EPC STORMWATER REVIEW COMMENTS
IN ORANGE BOXES WITH BLACK TEXT

GRANDWOOD RANCH

ROAD AND STORM PLANS

FURROW ROAD PLAN

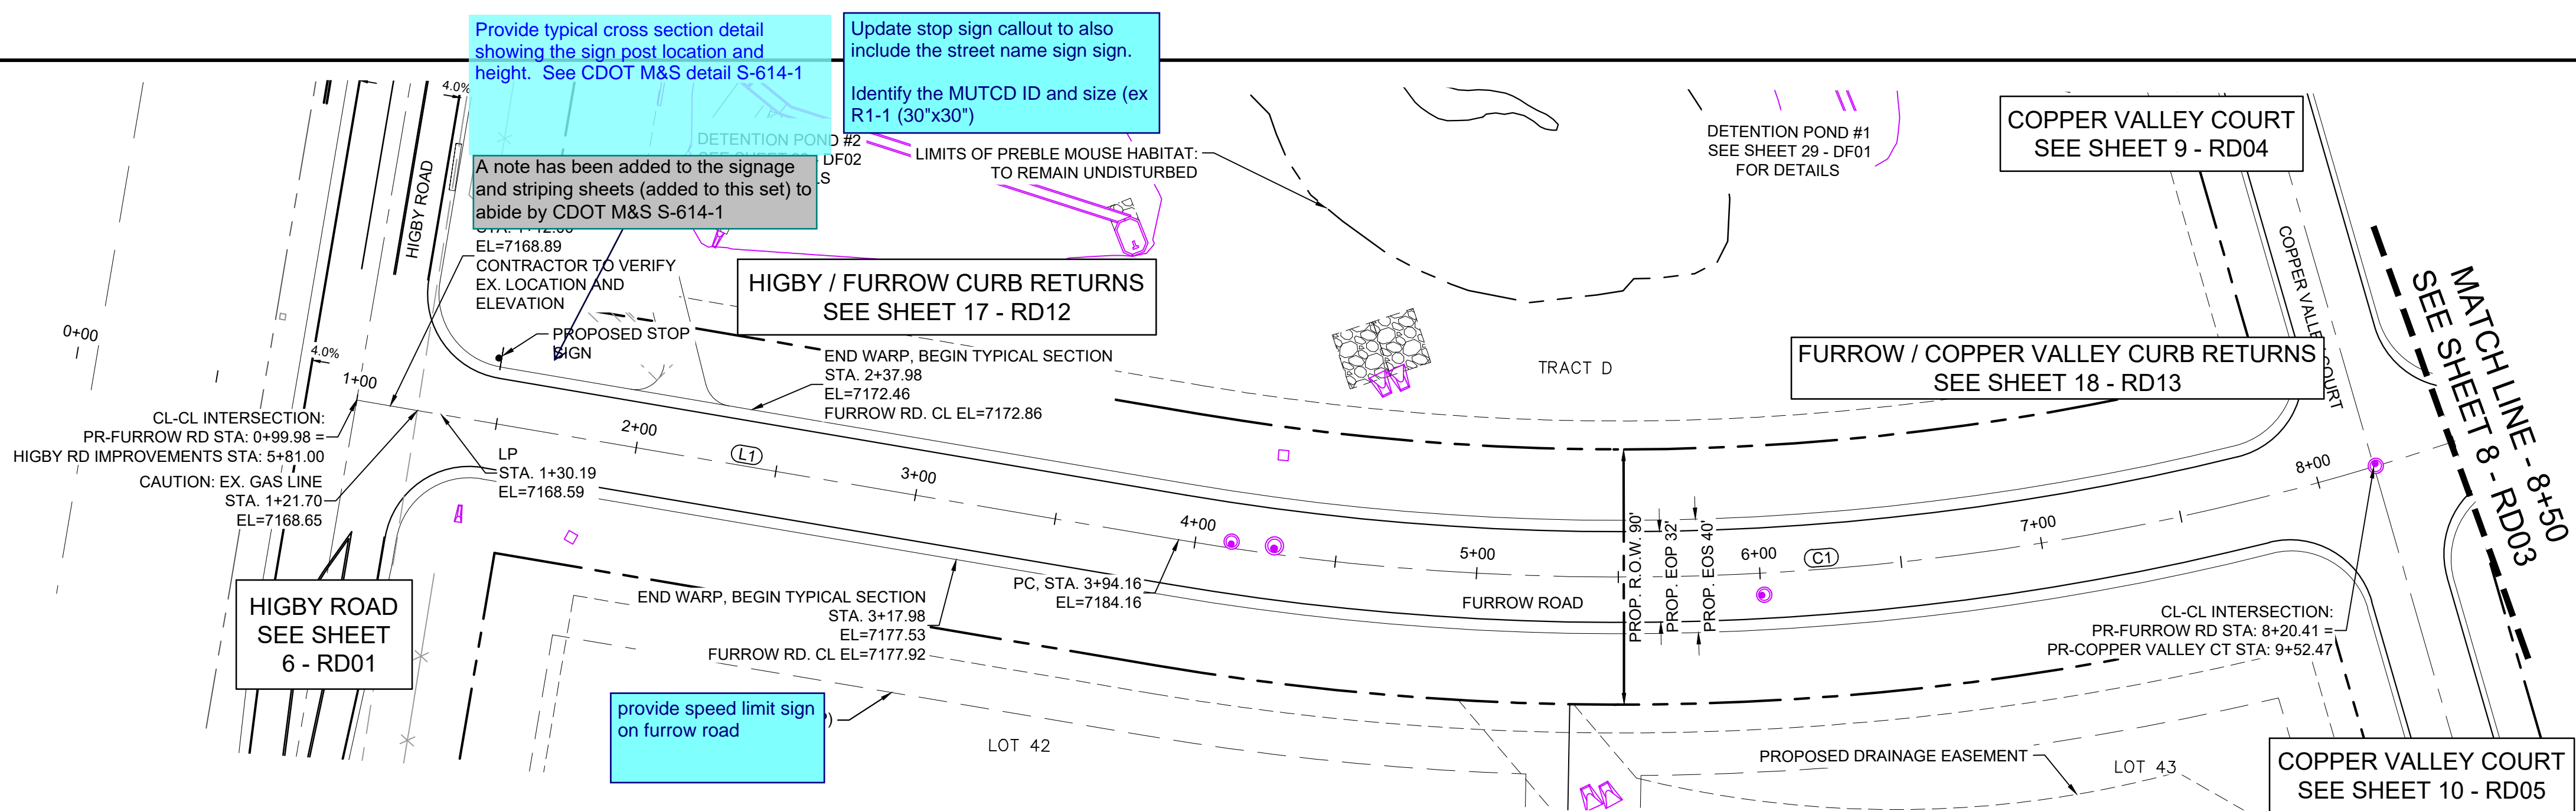
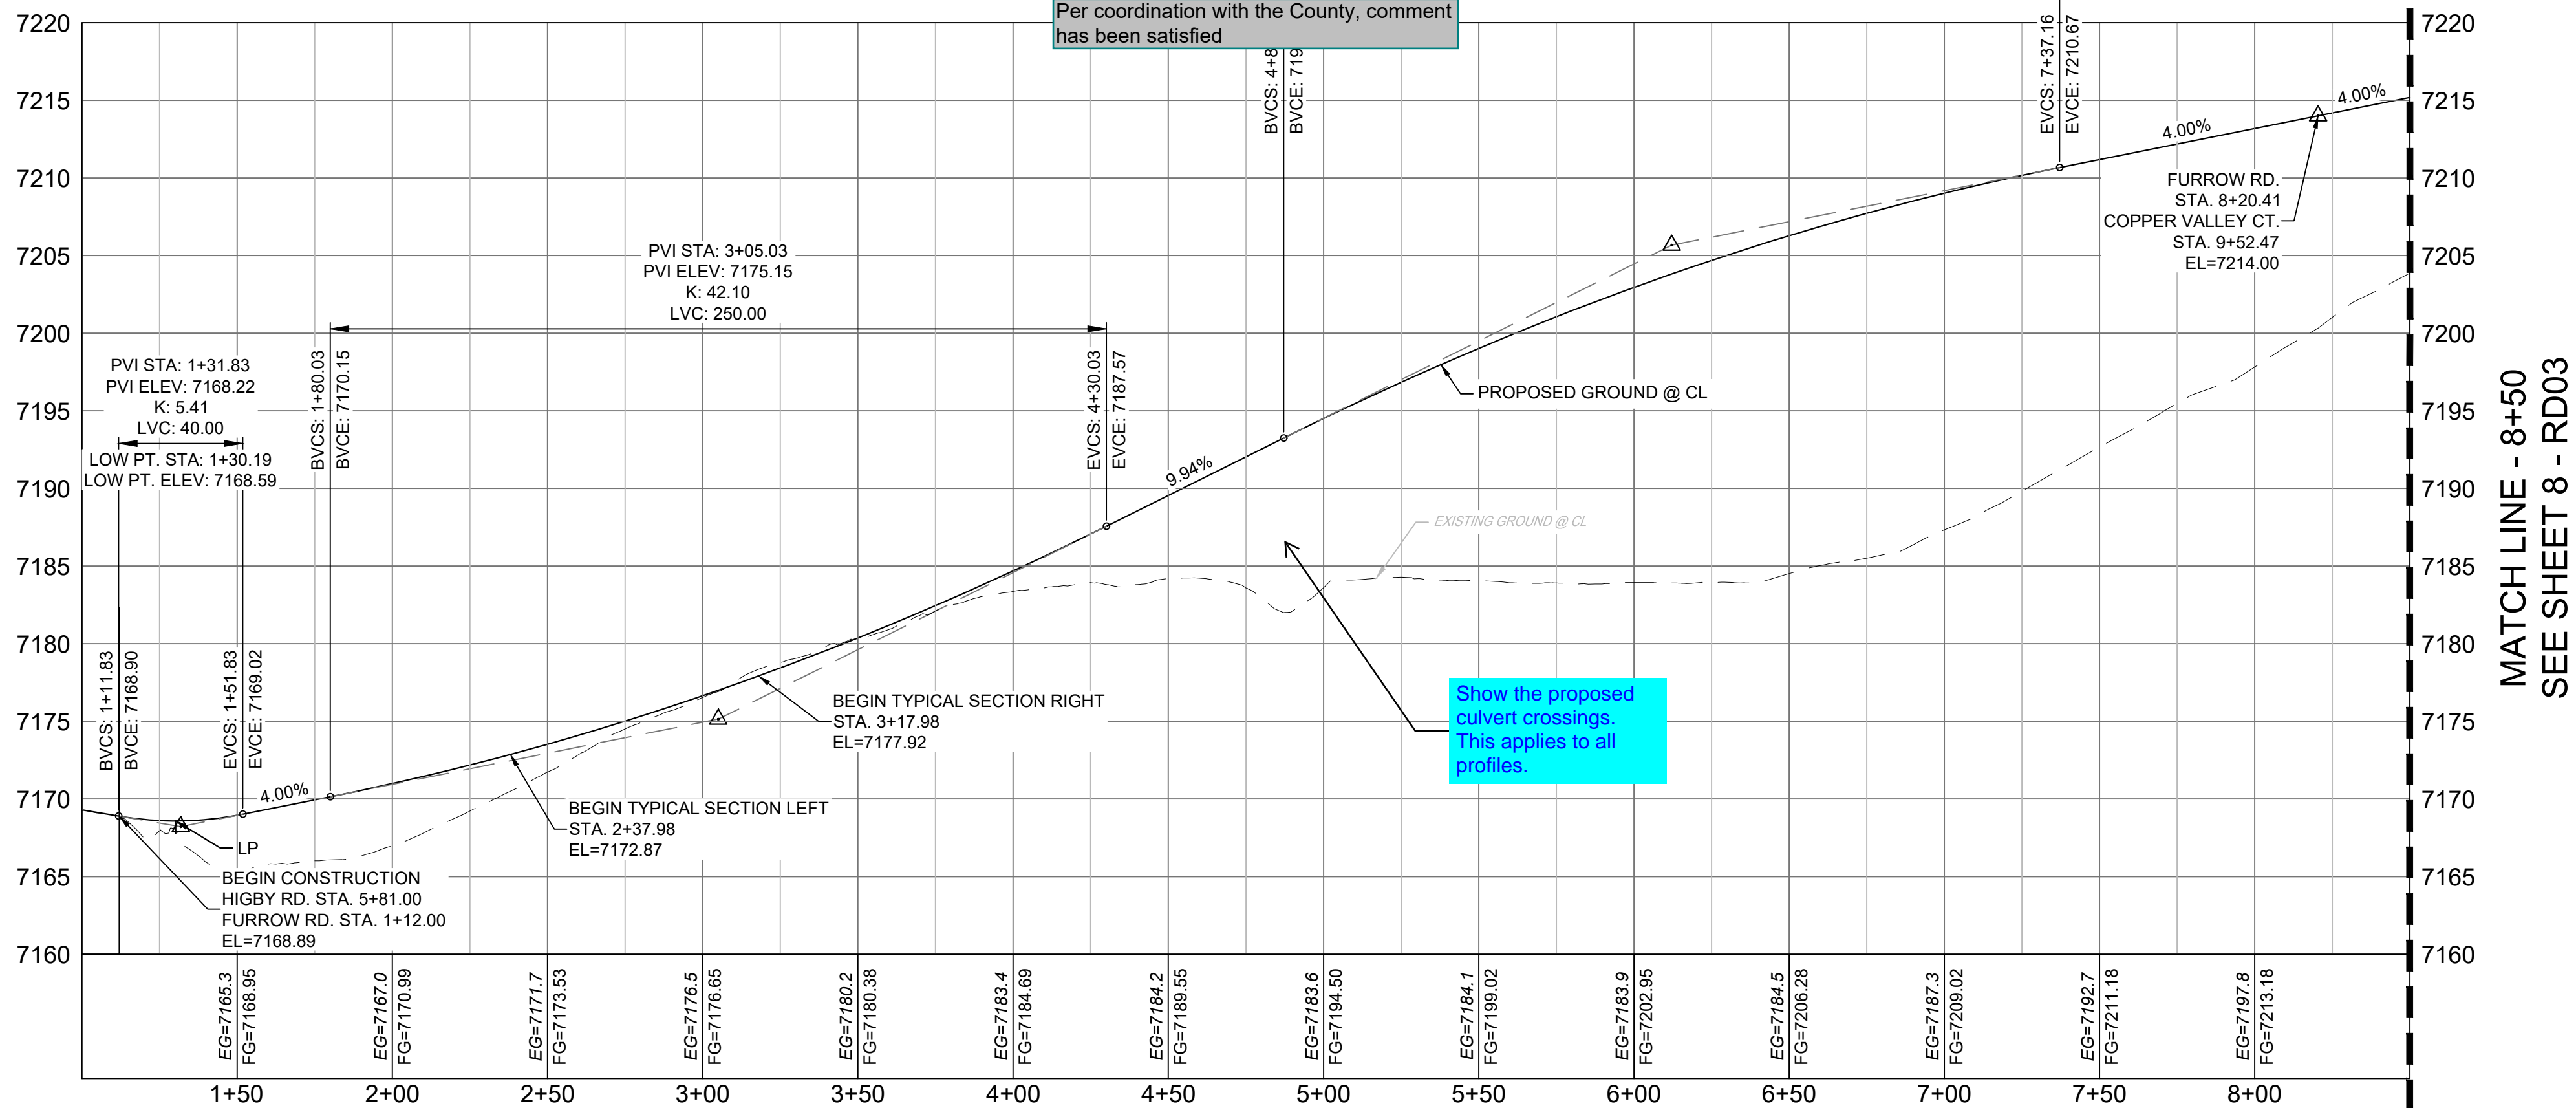
2. LANE LINES
- Specify yellow striping width and spacing between the double yellow. See snippet above from the CDOT M&S standards

Missing pavement markings for left turn lane. Revise to include relevant markings per CDOT M&S Standards section.

Slope does not match 'minor arterial cross section' slope of 2%

Revise all pavement markings per CDOT MS standards, pavement markings.

Scale should be minimum of 1 inch= 50 ft for subdivision work. Revise scale.

Please provide line of sight and sight distance should be marked on plans. Per ECM 2.3.7.C.5

Min K does not meet the approved deviation request (K=44)

1" = 40' is a common scale, accepted by the County and larger than the required 1" = 50' scale

Sight distance lines have been added to the signage and striping plans (added to this set)

Per coordination with the County, comment has been satisfied

FURROW ROAD PLAN

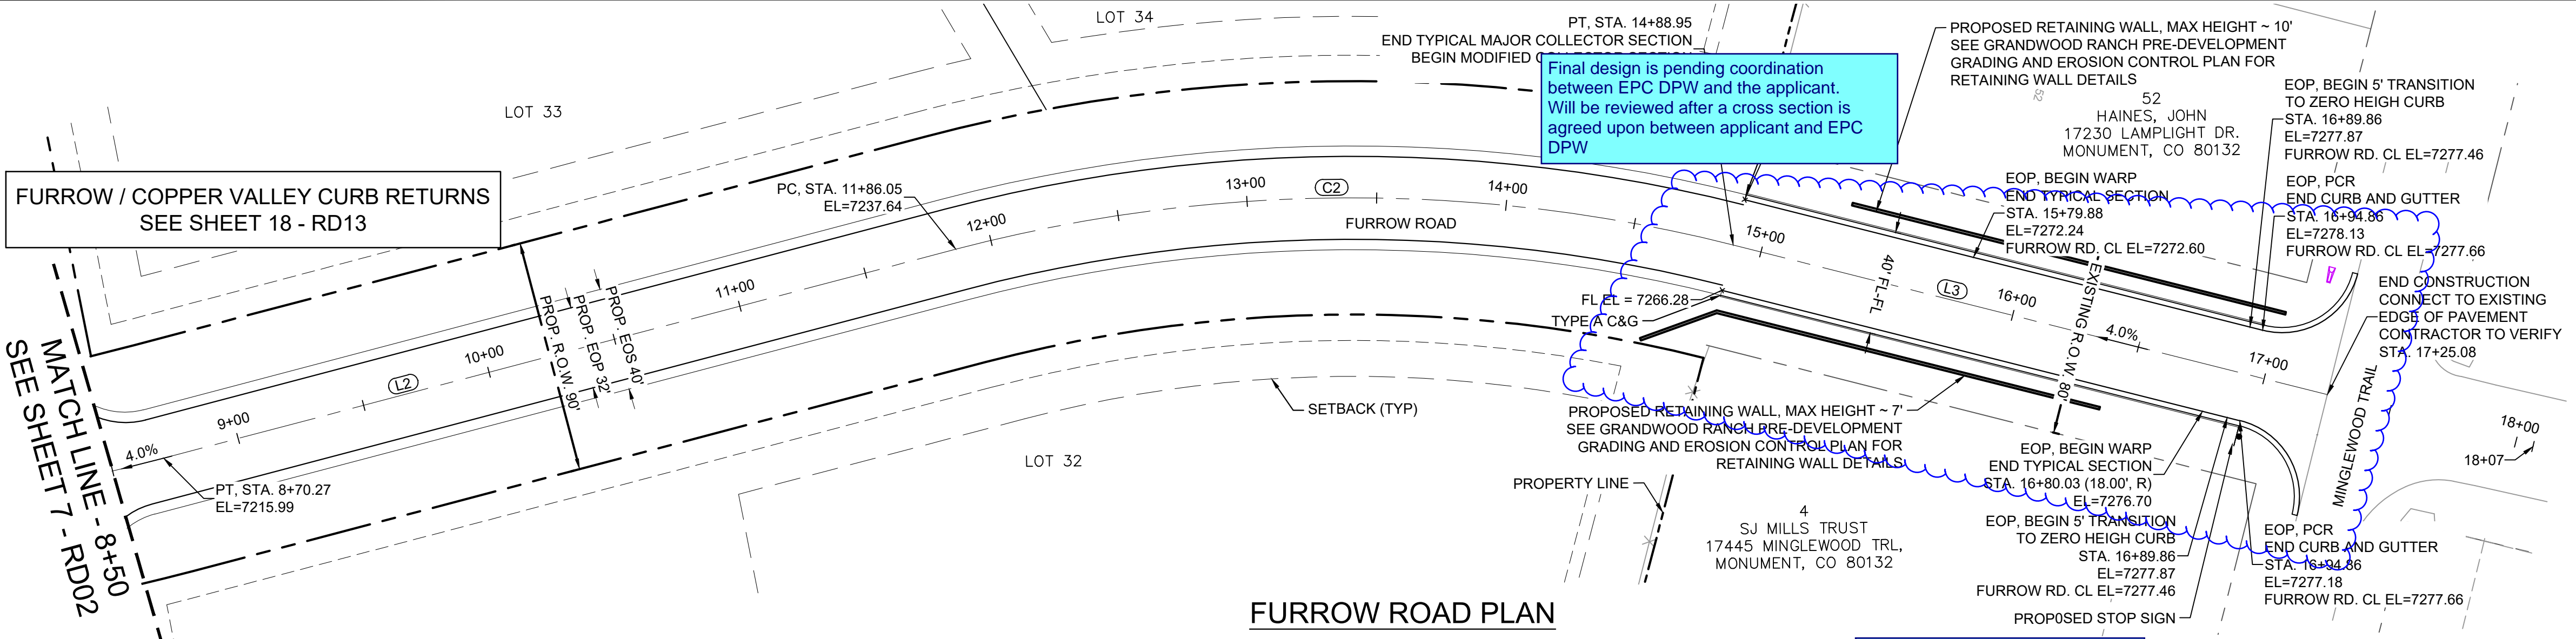
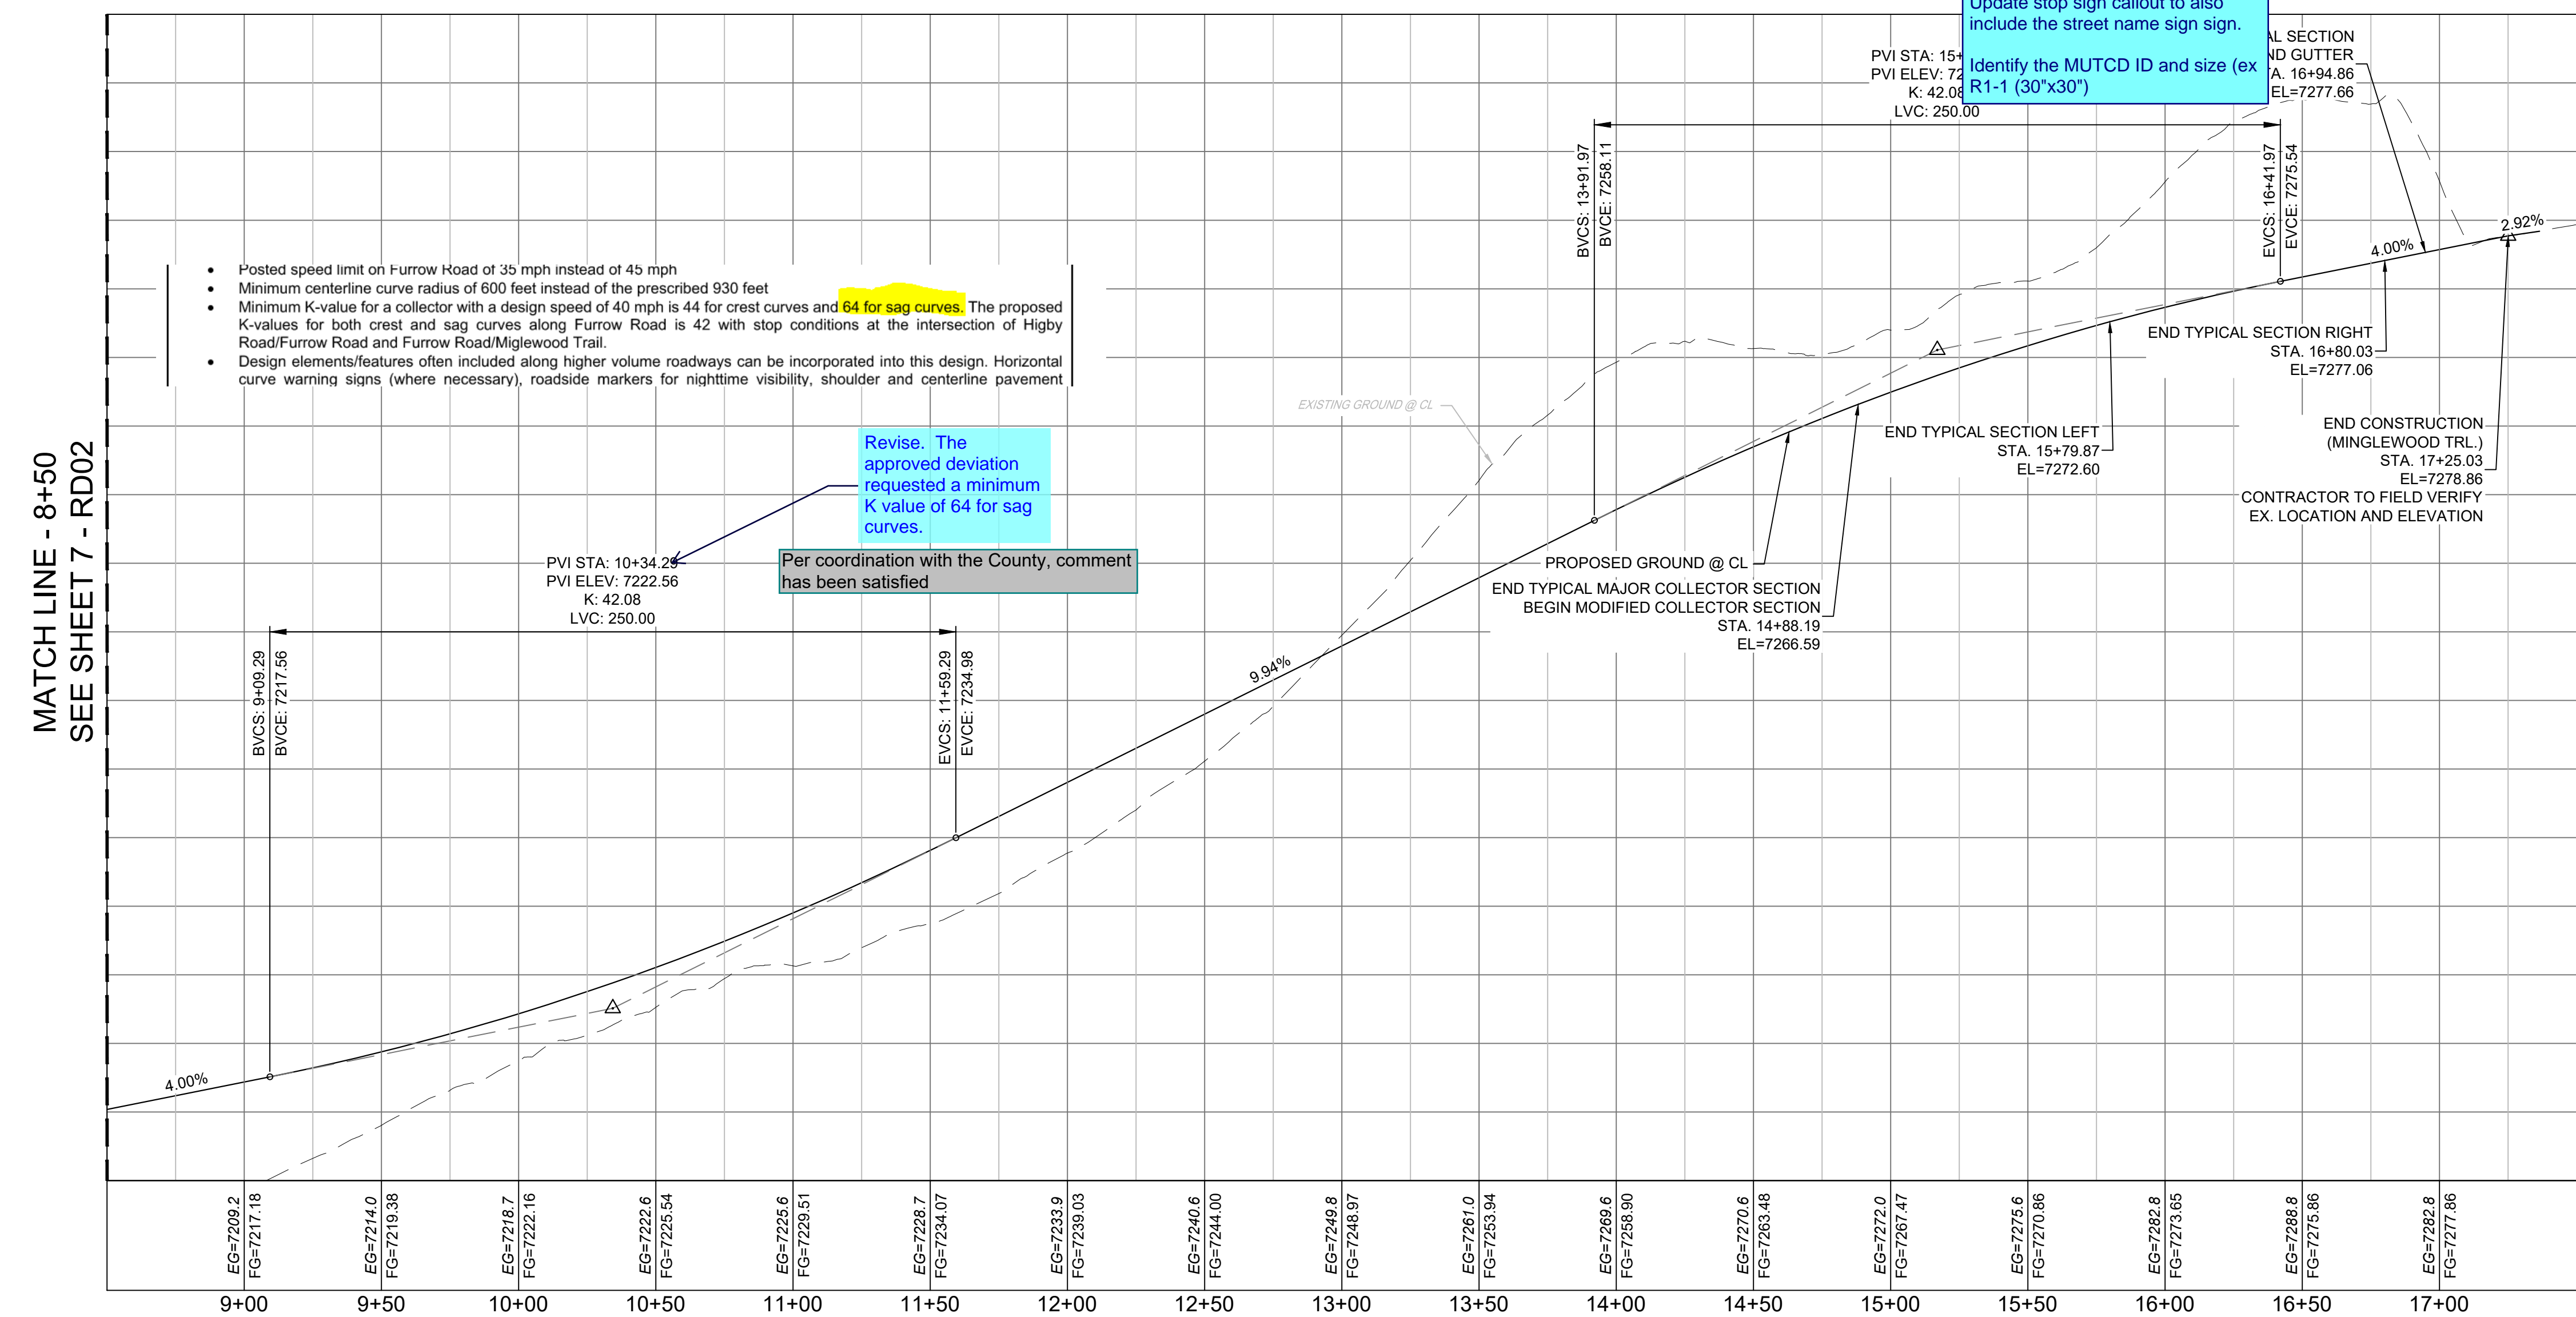
Revise intersection spacing to meet requirements of ECM 2.3.2.

Per coordination with the County, comment has been satisfied
